PROJECT  
KIDDERPORE AVENUE

DRAWING  
Skeel Library  
Basement Floor Details - Sheet 1

SCALE	DATE
1:5 @ A1	Nov 2016
DRAWING No.	DRAWN BY
15 230	ST
9000-DRG-00SK-DE003	REVISION
	C1

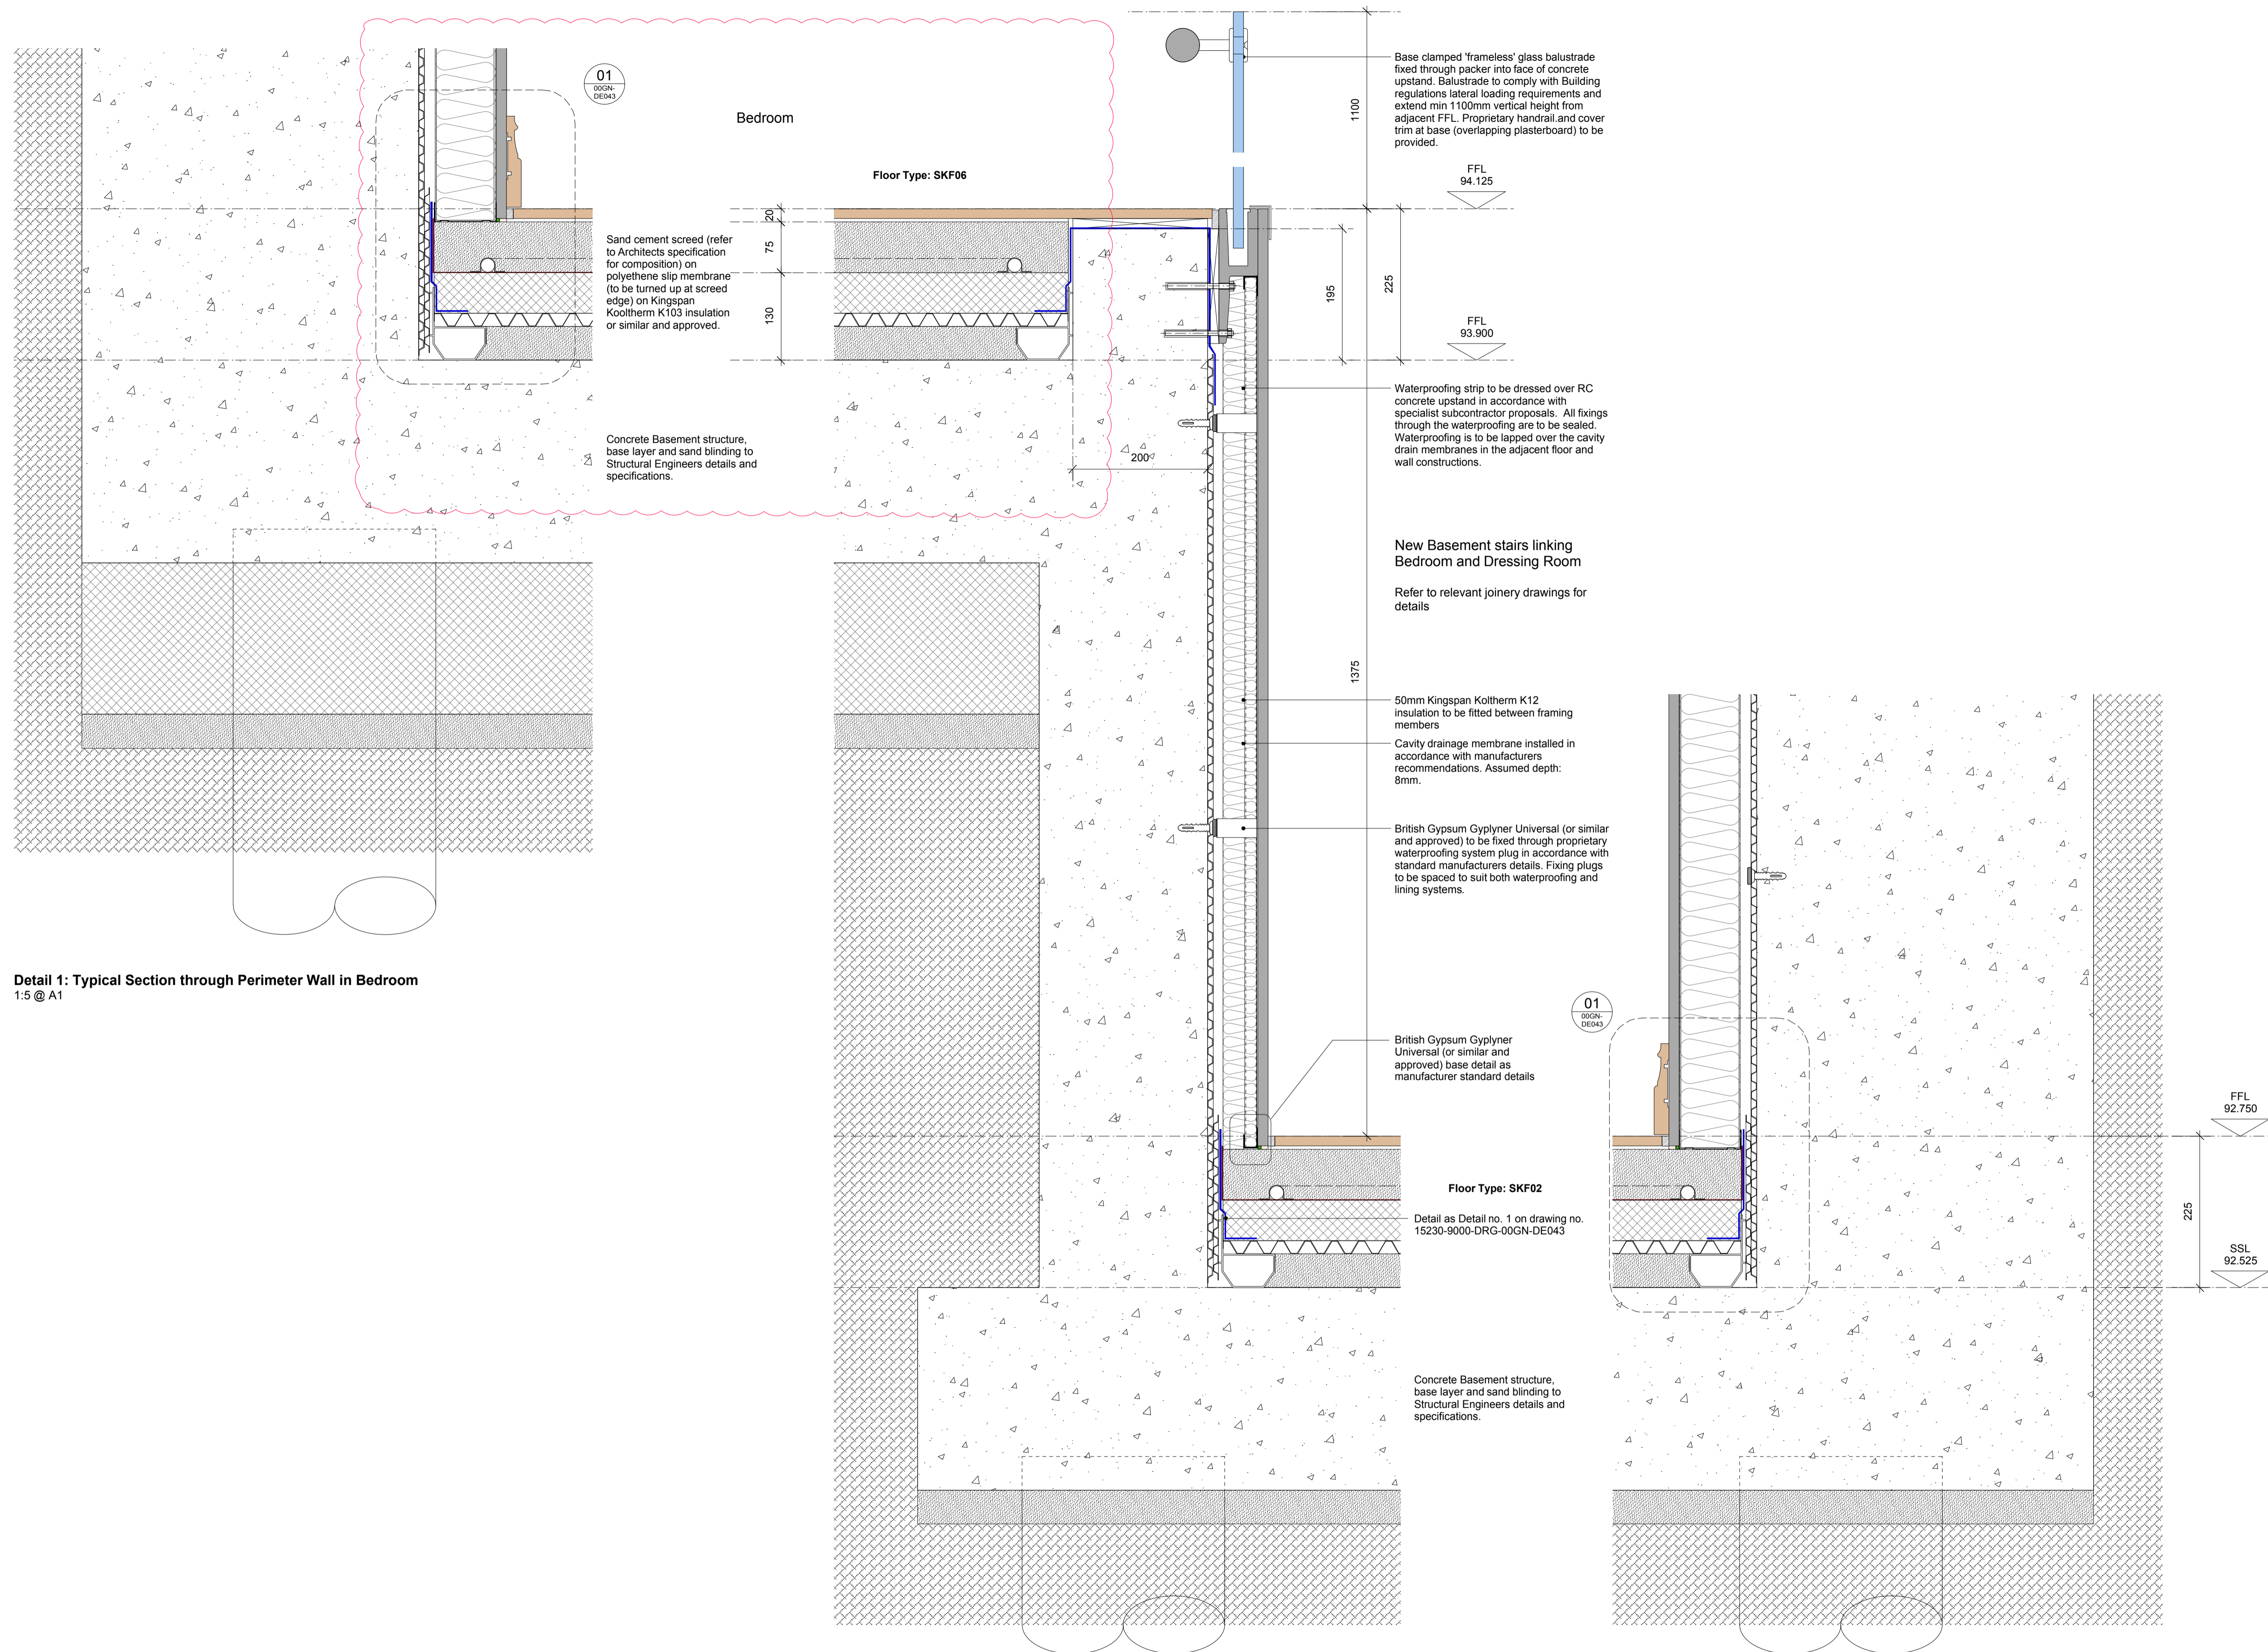
REVISION	DRN	CHKD	DATE
T1 First Issue	ST	TW	18.11.16
C1 Construction Issue. Upper level amended from voltex to drained cavity construction at client request.	ST	TW	12.12.16
